HSA-10/CC54C

TRACC TRANSITION TO
CONCRETE SAFETY SHAPE BARRIER
PLAN, ELEVATION & SECTIONS

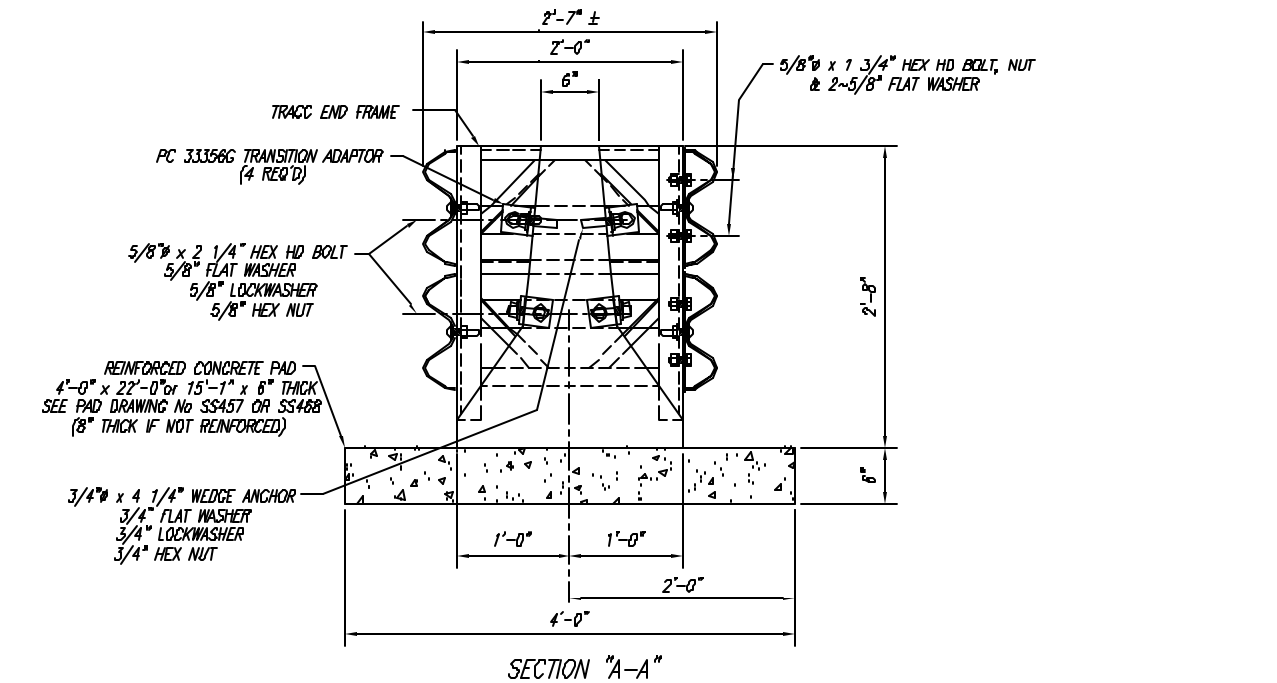
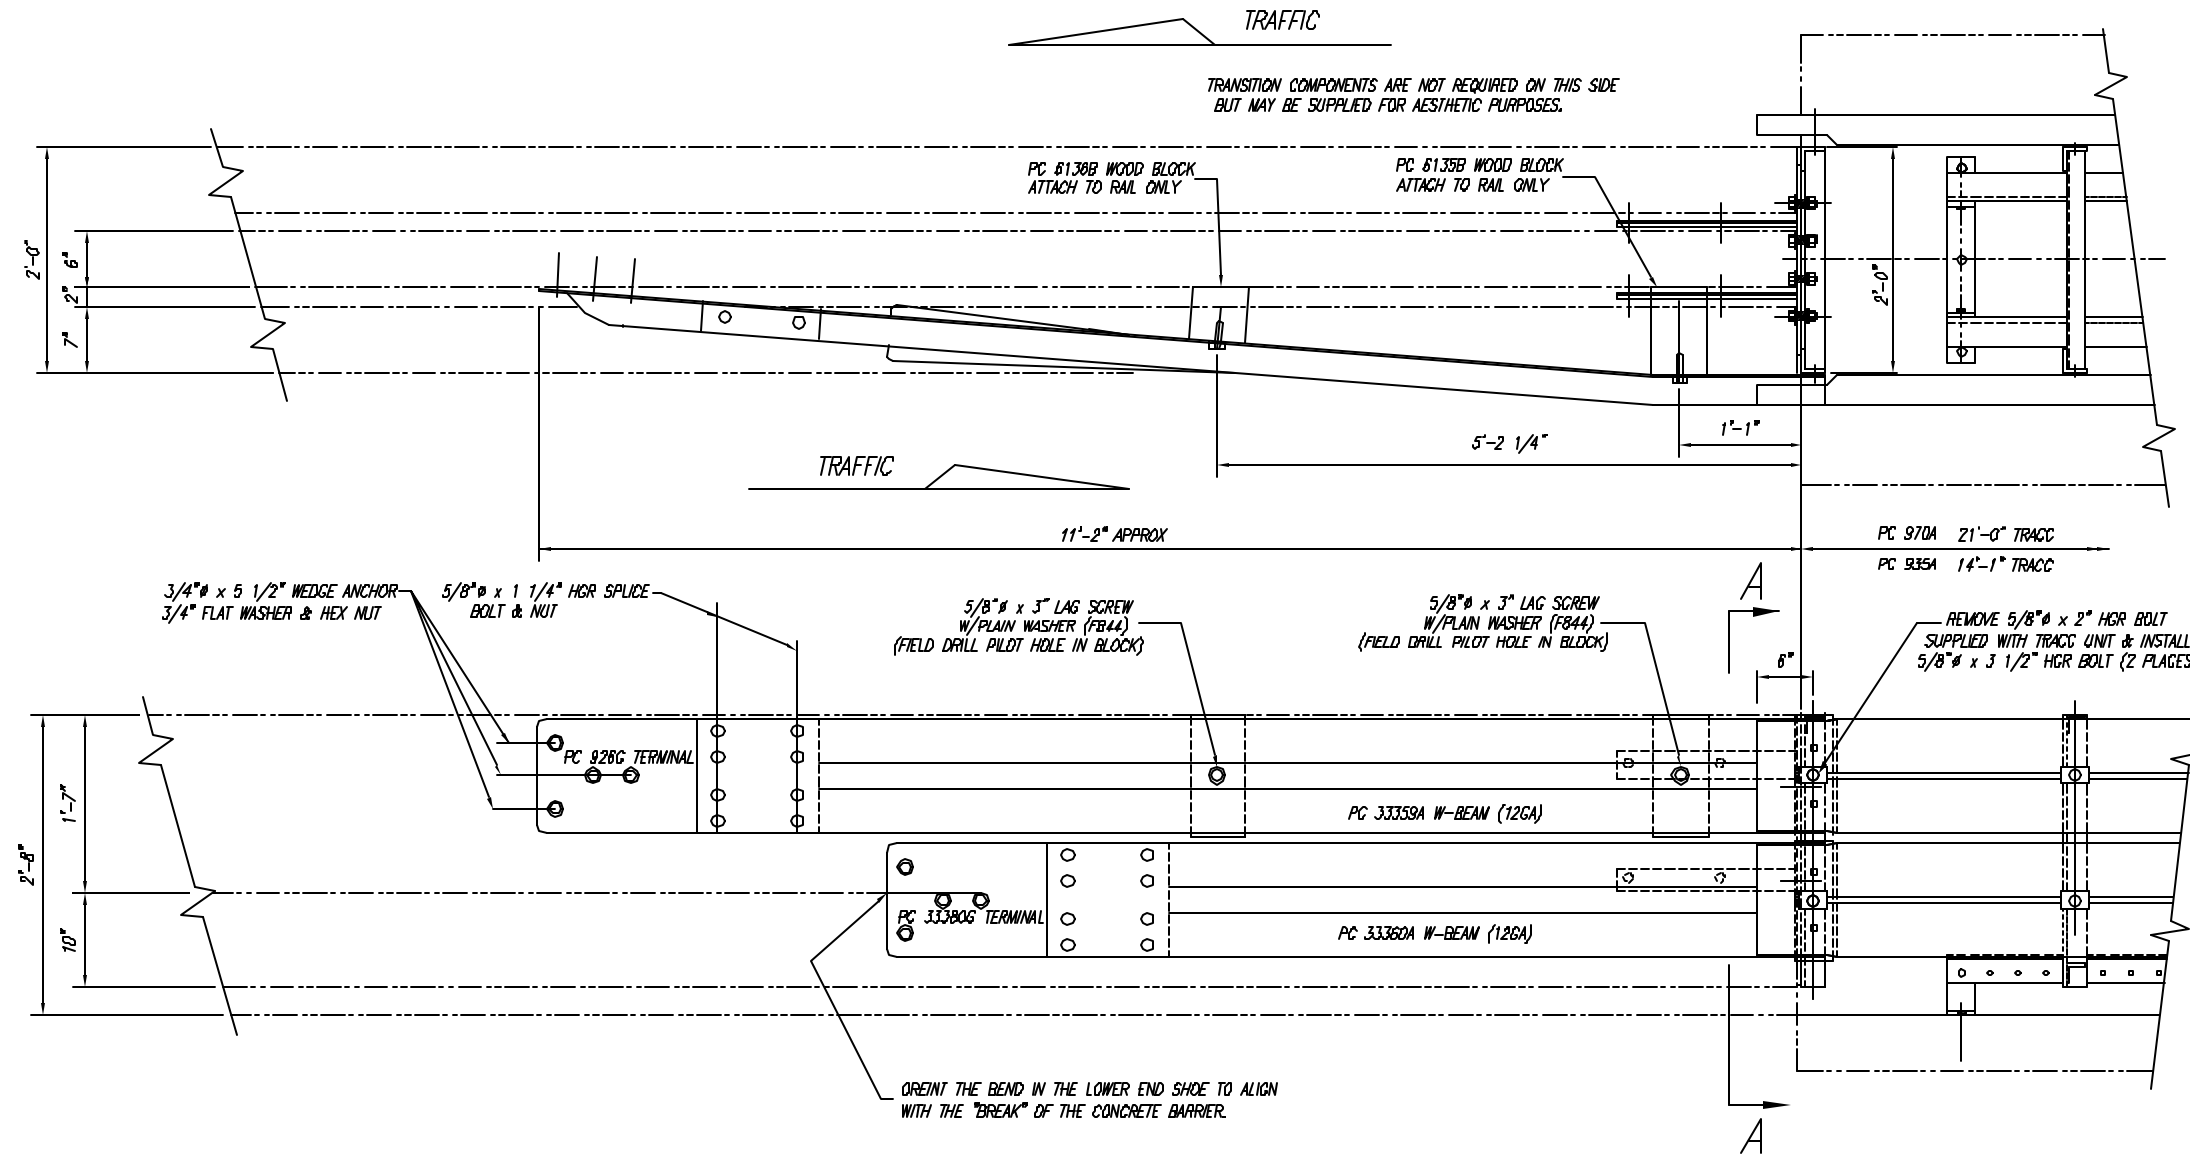
Following staff review of your proposed transitions, several modifications were recommended for the connection to the New Jersey concrete shape. The final design, as shown in the enclosed drawing dated 05/10/02, is considered acceptable for use on the National Highway System and replaces the drawing previously included in the TRACC Design Manual. The w-beam and Thrie-beam transition designs are acceptable as currently shown in the TRACC Design Manual. The reduced post spacings shown for the metal-beam median barriers are consistent with several bridge rail transition designs that have been successfully crash tested to NCHRP Report 350 criteria. In lieu of the 10-gauge w-beam sections shown in your transition drawings, nested 12-gauge w-beam could be used, just as it is in all crashworthy bridge rail transition designs.
